正誤表(16)

工事名) 北陸自動車道 R4長岡管内コンクリート構造物補修工事

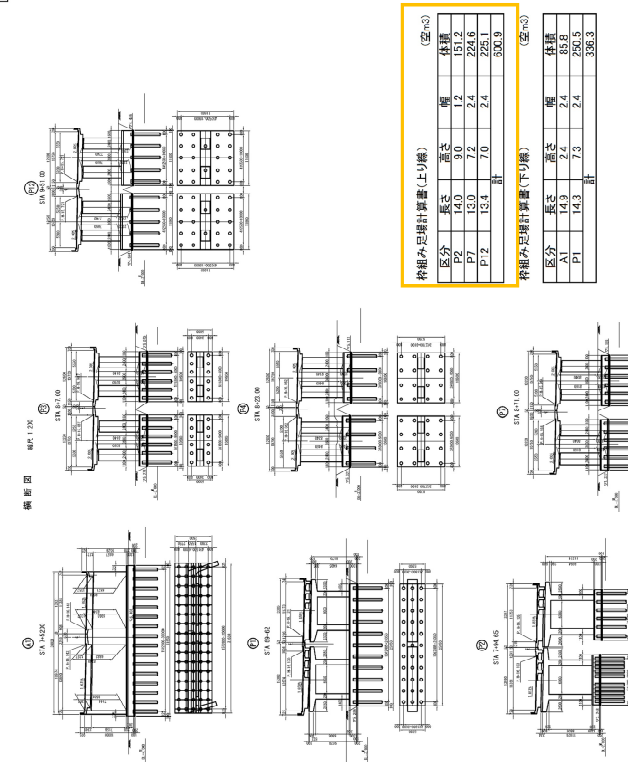
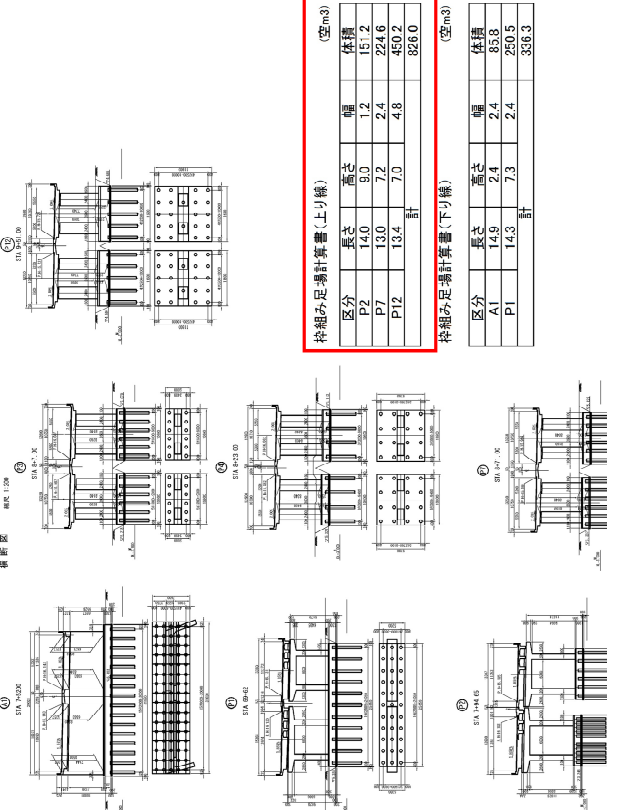
対象 参考図 (9/12)	誤	正																																																																																										
<p>9/12</p>	<p>足場工費 下須坂高架橋 (その3)</p>  <table border="1" data-bbox="801 375 918 654"> <caption>枠組み足場計算書(上り線) (空m<sup>3</sup>)</caption> <thead> <tr> <th>区分</th> <th>長さ</th> <th>高さ</th> <th>幅</th> <th>体積</th> </tr> </thead> <tbody> <tr> <td>P2</td> <td>14.0</td> <td>9.0</td> <td>1.2</td> <td>151.2</td> </tr> <tr> <td>P7</td> <td>13.0</td> <td>7.2</td> <td>2.4</td> <td>224.6</td> </tr> <tr> <td>P12</td> <td>13.4</td> <td>7.0</td> <td>2.4</td> <td>225.1</td> </tr> <tr> <td>計</td> <td></td> <td></td> <td></td> <td>599.9</td> </tr> </tbody> </table> <table border="1" data-bbox="918 375 996 654"> <caption>枠組み足場計算書(下り線) (空m<sup>3</sup>)</caption> <thead> <tr> <th>区分</th> <th>長さ</th> <th>高さ</th> <th>幅</th> <th>体積</th> </tr> </thead> <tbody> <tr> <td>A1</td> <td>14.3</td> <td>2.4</td> <td>2.4</td> <td>85.9</td> </tr> <tr> <td>P1</td> <td>14.3</td> <td>7.3</td> <td>2.4</td> <td>326.3</td> </tr> <tr> <td>計</td> <td></td> <td></td> <td></td> <td>412.2</td> </tr> </tbody> </table>	区分	長さ	高さ	幅	体積	P2	14.0	9.0	1.2	151.2	P7	13.0	7.2	2.4	224.6	P12	13.4	7.0	2.4	225.1	計				599.9	区分	長さ	高さ	幅	体積	A1	14.3	2.4	2.4	85.9	P1	14.3	7.3	2.4	326.3	計				412.2	<p>9/12</p> <p>足場工費 下須坂高架橋 (その3)</p>  <table border="1" data-bbox="1691 311 1807 670"> <caption>枠組み足場計算書(上り線) (空m<sup>3</sup>)</caption> <thead> <tr> <th>区分</th> <th>長さ</th> <th>高さ</th> <th>幅</th> <th>体積</th> </tr> </thead> <tbody> <tr> <td>P2</td> <td>14.0</td> <td>9.0</td> <td>1.2</td> <td>151.2</td> </tr> <tr> <td>P7</td> <td>13.0</td> <td>7.2</td> <td>2.4</td> <td>224.6</td> </tr> <tr> <td>P12</td> <td>13.4</td> <td>7.0</td> <td>4.8</td> <td>450.2</td> </tr> <tr> <td>計</td> <td></td> <td></td> <td></td> <td>826.0</td> </tr> </tbody> </table> <table border="1" data-bbox="1814 311 1915 670"> <caption>枠組み足場計算書(下り線) (空m<sup>3</sup>)</caption> <thead> <tr> <th>区分</th> <th>長さ</th> <th>高さ</th> <th>幅</th> <th>体積</th> </tr> </thead> <tbody> <tr> <td>A1</td> <td>14.9</td> <td>2.4</td> <td>2.4</td> <td>85.8</td> </tr> <tr> <td>P1</td> <td>14.3</td> <td>7.3</td> <td>2.4</td> <td>250.5</td> </tr> <tr> <td>計</td> <td></td> <td></td> <td></td> <td>336.3</td> </tr> </tbody> </table>	区分	長さ	高さ	幅	体積	P2	14.0	9.0	1.2	151.2	P7	13.0	7.2	2.4	224.6	P12	13.4	7.0	4.8	450.2	計				826.0	区分	長さ	高さ	幅	体積	A1	14.9	2.4	2.4	85.8	P1	14.3	7.3	2.4	250.5	計				336.3

区分	長さ	高さ	幅	体積																																																																																								
P2	14.0	9.0	1.2	151.2																																																																																								
P7	13.0	7.2	2.4	224.6																																																																																								
P12	13.4	7.0	2.4	225.1																																																																																								
計				599.9																																																																																								
区分	長さ	高さ	幅	体積																																																																																								
A1	14.3	2.4	2.4	85.9																																																																																								
P1	14.3	7.3	2.4	326.3																																																																																								
計				412.2

区分	長さ	高さ	幅	体積																																																																																								
P2	14.0	9.0	1.2	151.2																																																																																								
P7	13.0	7.2	2.4	224.6																																																																																								
P12	13.4	7.0	4.8	450.2																																																																																								
計				826.0																																																																																								
区分	長さ	高さ	幅	体積																																																																																								
A1	14.9	2.4	2.4	85.8																																																																																								
P1	14.3	7.3	2.4	250.5																																																																																								
計				336.3

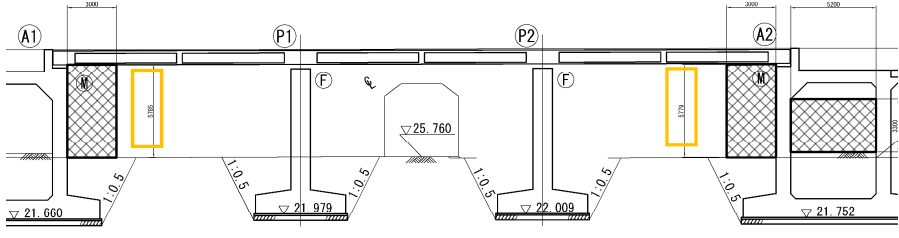
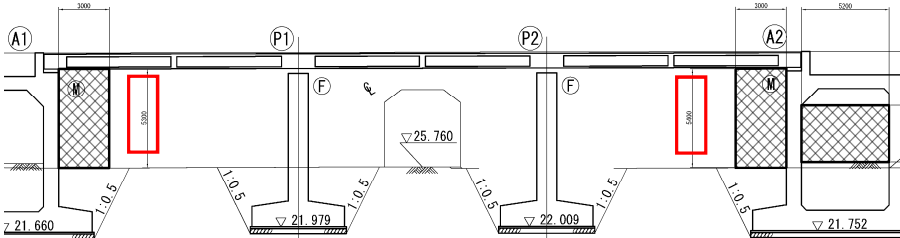
対象	誤	正
<p>参考図 (12/12)</p>	<p>縦断図 縮尺 1:200 足場工費 上中沢橋</p>  <p>▽ 21.660 1:0.5 21.979 25.760 P1 P2 22.009 1:0.5 21.752 A1 A2</p> <p>▽ 1:200 橋台</p>	<p>縦断図 縮尺 1:200 足場工費 上中沢橋</p>  <p>▽ 21.660 1:0.5 21.979 25.760 P1 P2 22.009 1:0.5 21.752 A1 A2</p>
